July 5, 2006

OG-06-213

Subject: Pressurized Water Reactor Owners Group
Responses to NRC Request for Additional Information Regarding
the Review of BAW-2461, "Risk Informed Justification for
Containment Isolation Valve Allowed Outage Time Change"
(LSC-0236)

Proposed Appendix to Topical Report BAW-2461 Implementation Guidance

Example of Ganged CIVs

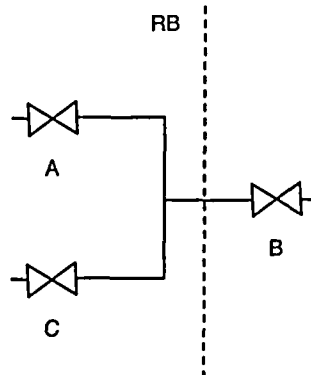
- 1) Determine if the CIV is on a penetration that has ganged CIVs; for example, some penetrations may have an outboard CIV that is in series with two or more parallel inboard CIVs (see example illustration below). If the penetration has ganged CIVs, then determine if the inoperable CIV affects one CIV pathway or multiple CIV pathways (consider only the CIVs). In the example, if CIV A is inoperable, then one flow path is affected (A:B). Similarly, only one flow path is affected for CIV C inoperable. However, if CIV B is inoperable, then two CIV flow paths are affected (A:B) and (C:B). Hence in the case of CIV B inoperable, the risk impact (from Table 3-3) is the sum of the two risk impacts, e.g., $ICLERP_{(A:B)} + ICLERP_{(C:B)}$.

Therefore, in cases where the postulated inoperable CIV is paired with multiple CIVs on the opposite side of the RB wall, perform steps 1 through 13 for each pair and sum the risk impacts.

Example of Boundary Options for Crediting Additional Valves in Risk Calculation

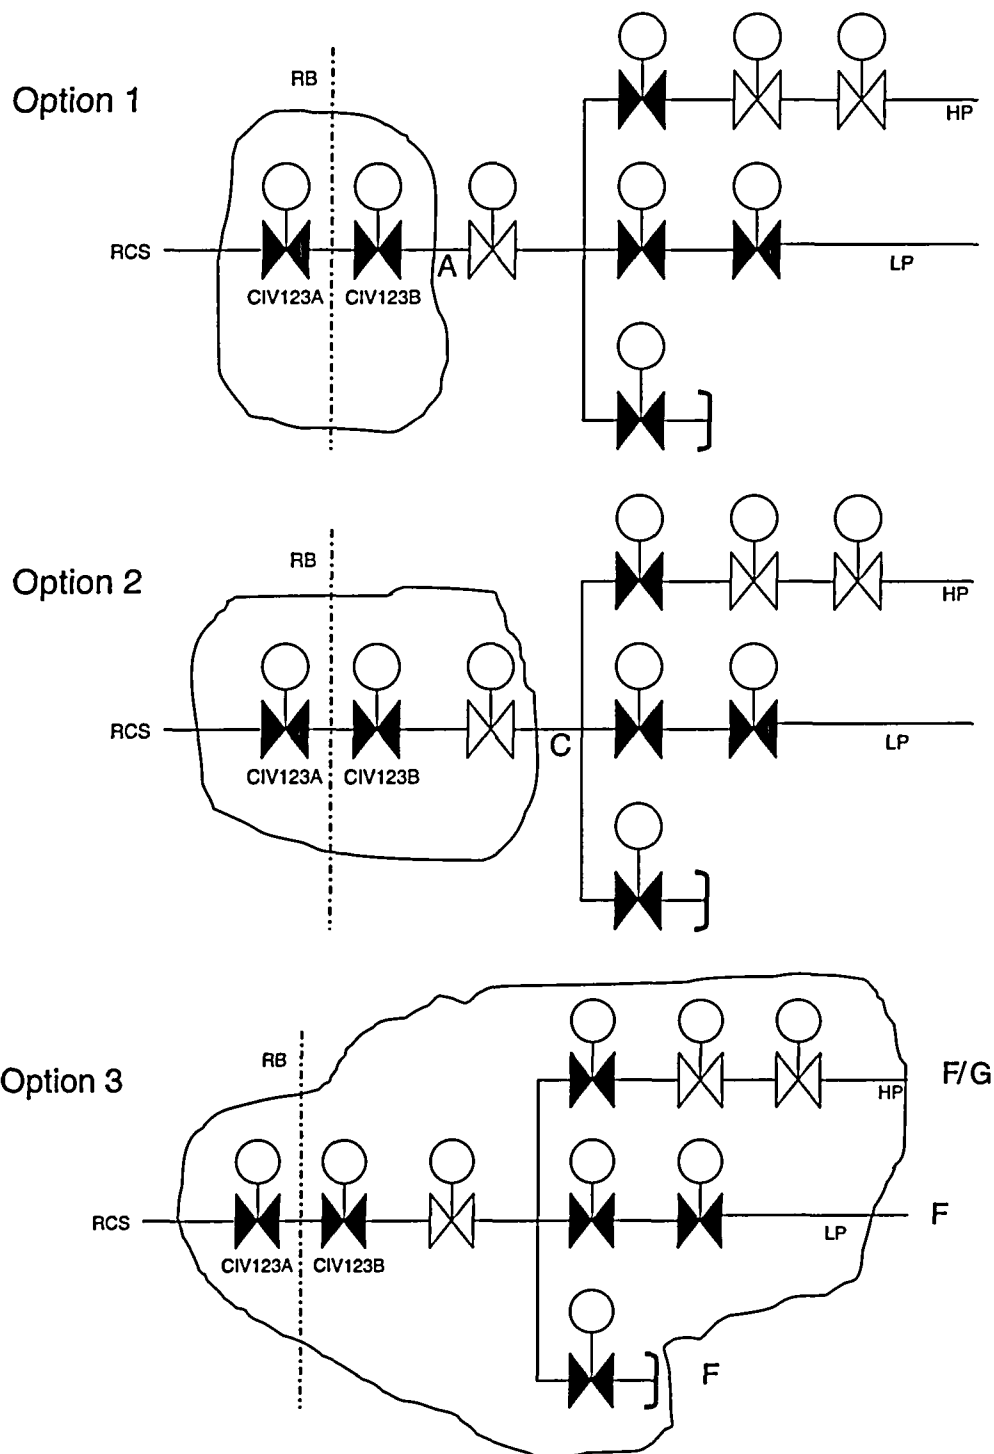
For example, see the simple example in the figure below. If the boundary is drawn around just the CIVs (option 1), then Configuration A is assumed for the outboard piping. In many cases, the open pipe assumption (A) produces acceptable risk, making it unnecessary to be concerned about the state of the system downstream of the CIVs. However, if the boundary is drawn to include the additional NO MOV (option 2), then Configuration C is assumed, improving the risk. The boundary can also be drawn larger to credit additional valves (option 3); in this case, all of the pathways have at least three additional valves (cap on pipe end is counted as a valve) before the low-pressure piping, and configuration F is used for each.
